**ITEM 9.2**                      **PROPONENT INITIATED PLANNING PROPOSAL - 171-179 GREAT NORTH ROAD & 1A-1B HENRY STREET, FIVE DOCK****Reporting Manager**      **Manager Strategic Planning**

To provide Council with the outcome of the assessment of a Planning Proposal relating to 171-179 Great North Road & 1A-1B Henry Street, Five Dock and seek Council endorsement to submit the Planning Proposal to the Department of Planning, Housing and Infrastructure (DPHI) seeking a Gateway Determination.

Figure 14: Proponent proposed building heights

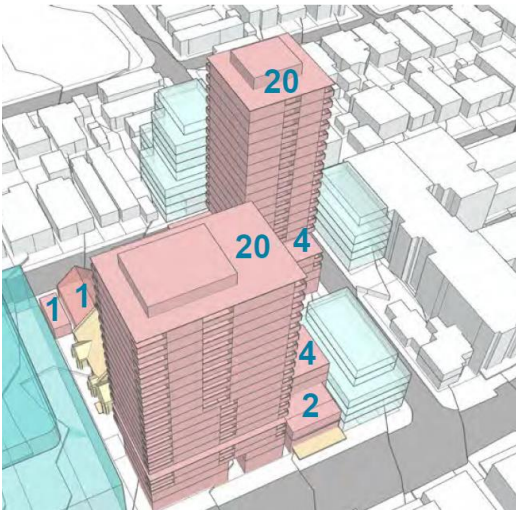
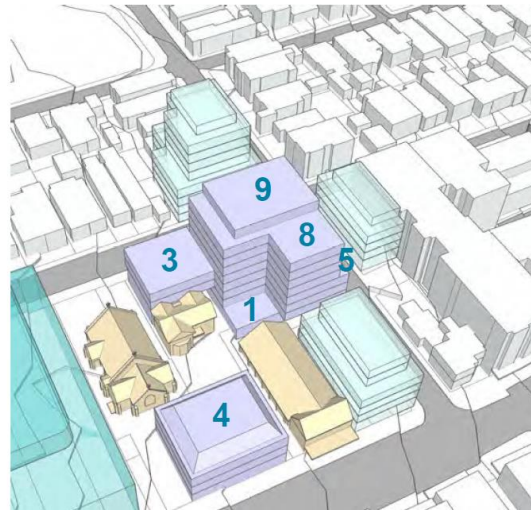
Whilst the location of the Metro Station adjacent to the site represents an opportunity for increased development, it is not justification for the 75m maximum height proposed and two towers of that height. The scale of the proposed 75m towers is out of context with the existing and desired mid-rise character of the Five Dock Town Centre (and with the heights proposed in the EIE for low- and mid-rise housing). If the forecast heights are compared with the illustrated heights in the Planning Proposal, it is apparent that the proposed towers will be out of context within the future town centre.

The proposed 75m maximum building height is not supported.

Figure 18: Proponent Planning Proposal – built form

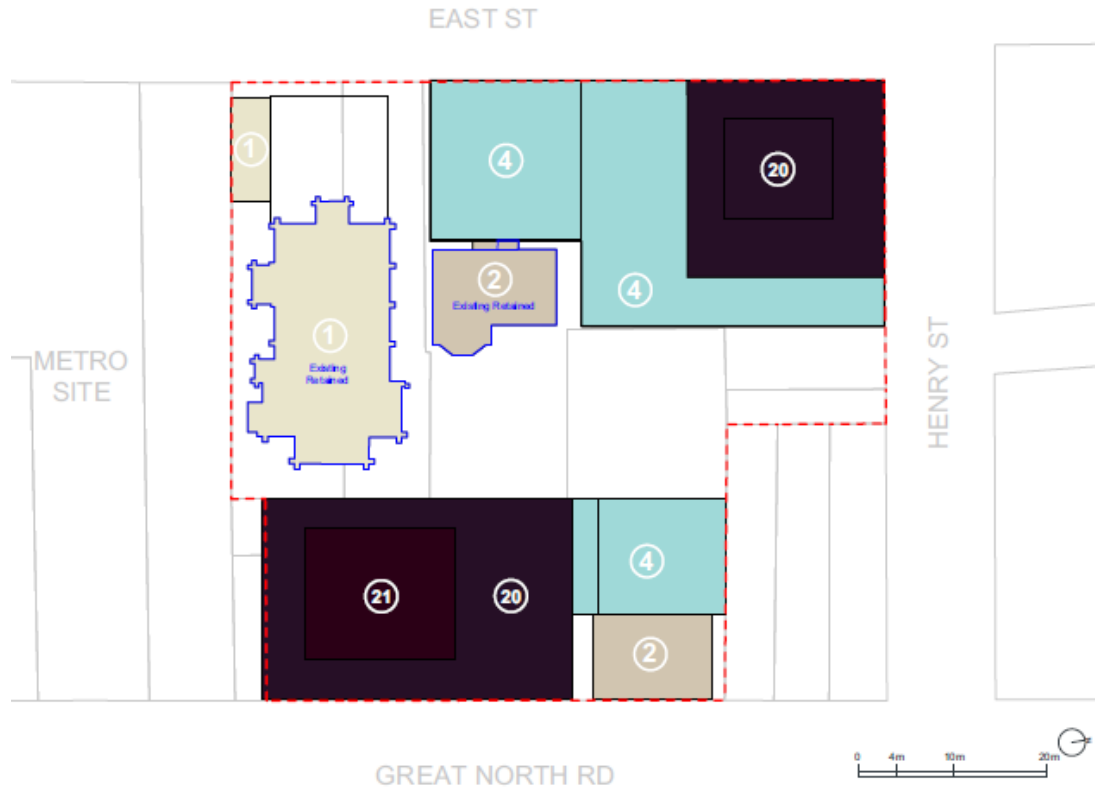
The Planning Proposal request to amend the maximum FSR standard from 2.5:1 to 4.5:1 is not supported.

The existing site FSR of 2.5:1, applies to most properties along Great North Road, and assumes development can be built boundary to boundary, reflective of a main retail street in a town centre. The retention of heritage building on the site, combined with the concept considered by the LPP for built forms of up to 9 storeys, achieves an FSR of approximately 1.73:1. Whilst, this built form tested FSR is lower than the current permissible FSR of 2.5:1, this outcome is expected given the constraints associated with low the scale heritage buildings on the site and limits on development before the overshadowing Fred Kelly Place.

Retaining the existing maximum FSR of 2.5:1 is therefore recommended.

Figure 20: Level 4-podium (Proponent's Urban Design Report)

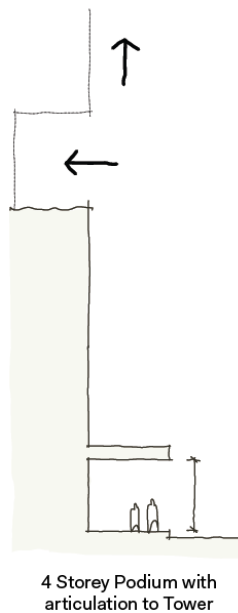
While the proposed podium is no taller than the transept of the church, the single level setback of the fifth storey, where the upper levels (storey 6 to storey 20) are cantilevered and built to the podium edge, means that the bulk and scale of the building dominates the heritage context.

Figure 23: Terminating view from Second Avenue (looking west) under the Proponent Planning Proposal.

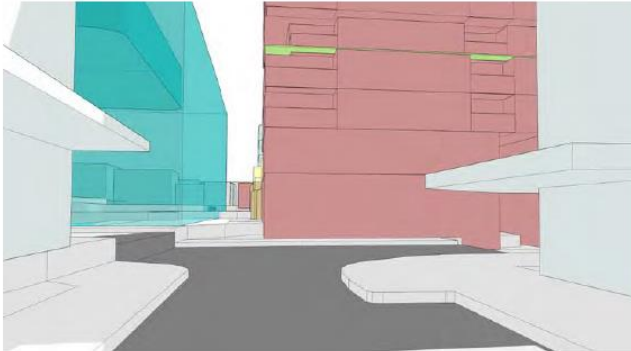
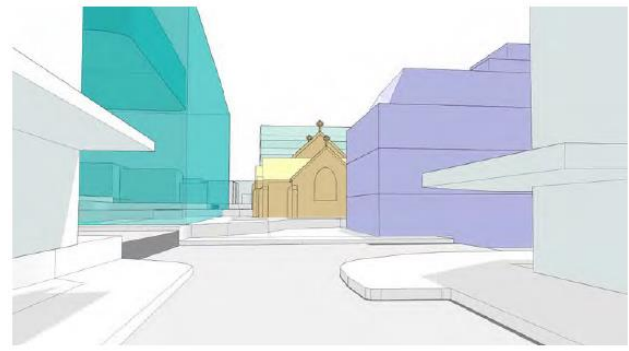
From Second Avenue, the podium is unsuccessful in reducing the perceived bulk and scale of the proposed tower fronting Great North Road. The existing view that frames the heritage listed Church and features green landscaping would be replaced by a large 20 storey tower that dominates the streetscape and blocks views of the Church.

It is recommended that the terminating view of the Church from Second Avenue (looking west) is retained so as to see, at a minimum, the heritage building between the southern boundary and the highest cross on the Church roof. An 8.0m setback from the southern site boundary to the development that fronts Great North Road, with a pitched roof form for the fourth storey, would achieve this outcome. However, this would still remove the church's historical setting, place and street address.

*Figure 27: Mid-winter shadows in Fred Kelly Place - Proponent proposal*

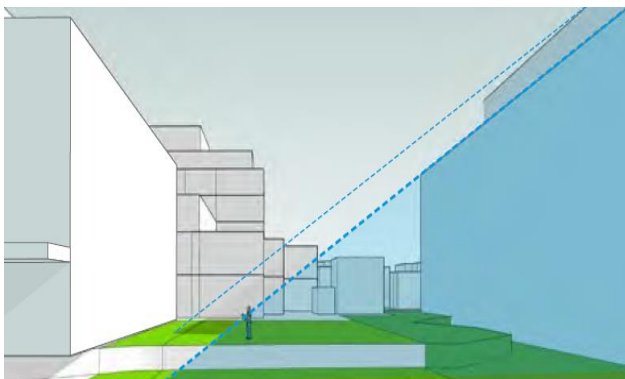
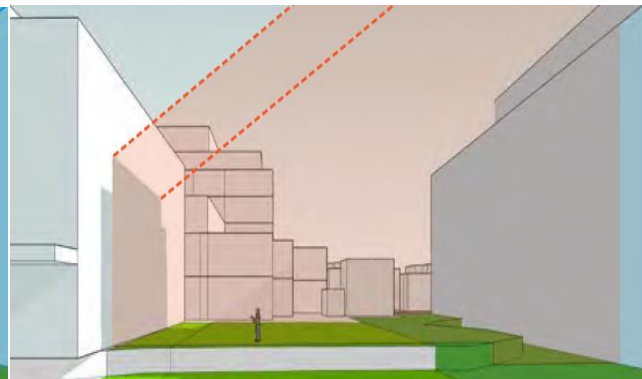
The proposed 75m heights of the 2 towers, which could potentially increase to 97.5m under Clause 18 of the Housing SEPP, will result in overshadowing of Great North Road, the surrounding local streets and the proposed new Town Square, which will comprise a wider Fred Kelly Place and future Plaza on the eastern side of Great North Road.

The alternative floor space ratio, building height and building envelope in the Council officers’ report as considered by the LPP, will enable a satisfactory level of solar access to surrounding open space and properties.

Figure 29: Proposed through-site links.

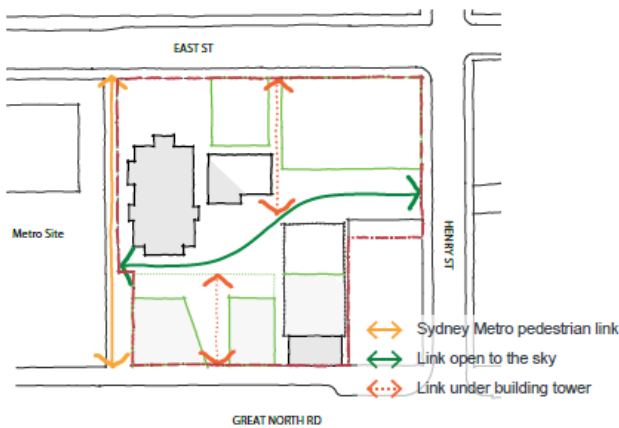
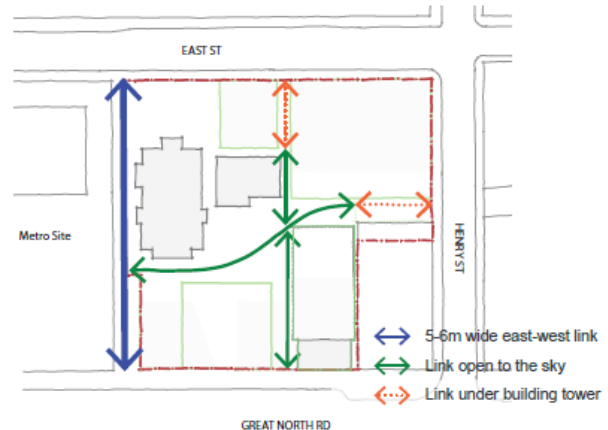
Three pedestrian links are proposed within the site boundary, none of which provide a direct line of sight from one end to the other. This significantly restricts visual permeability and impacts safety and security for pedestrians.

It is recommended that the Planning Proposal supplement and enhance the Sydney Metro east-west link by making the space an open and uncovered landscaped setback to the Metro pedestrian link and by relocating the proposed Kitchenette and WC.

The alternative scheme outlined in the Council officers' report and considered by LPP includes revised through-site links to improve visual permeability by connecting the two east-west links. The revised scheme also enhances wayfinding for pedestrians by reducing the number of under-building pathways, where pedestrians are concealed.

Figure 31: Proponent proposal

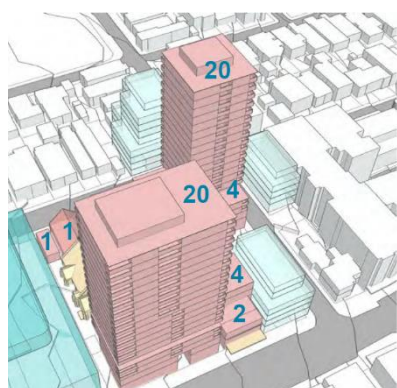
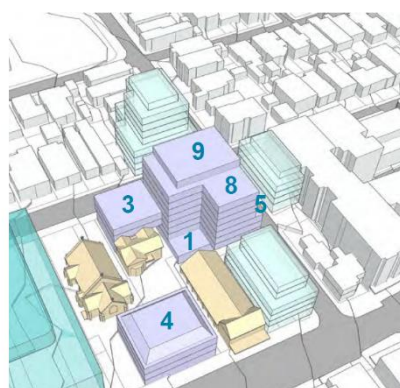
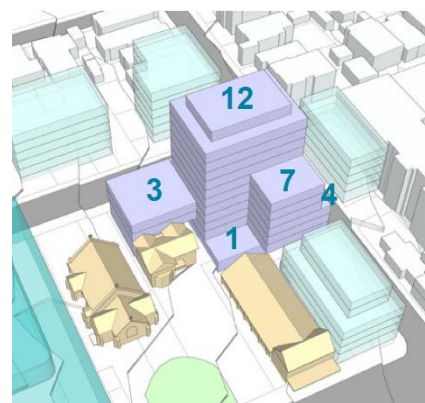
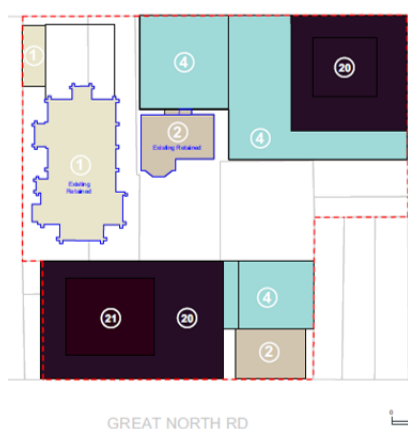
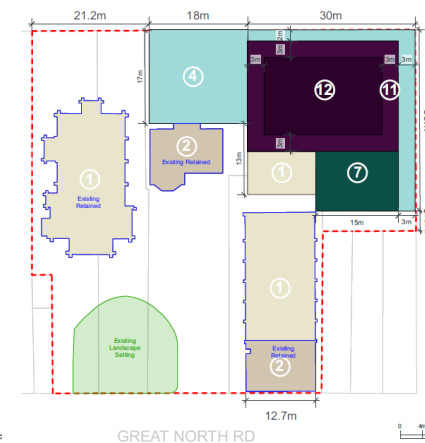
Following consideration of the discussion of the proposal by the Local Planning Panel, Council officers commissioned further analysis from Studio GL. Advice was specifically sought regarding the consequences of relocating the gross floor area that would have been located within the 4-storey building on Great North Road, considered by the LPP, to the residential tower in the north-western corner of the site. This analysis was sought to determine whether it was possible to retain the landscaped area in front of the church, whilst retaining the same quantum of floorspace recommended by Council officers and considered by the LPP, without adverse impacts on Fred Kelly Place or surrounds.

The relocation of the floor space will result in a maximum building height of 39.5m (12 storeys) in that part of the site and no change to the FSR in the Council officers’ report considered by the LPP.
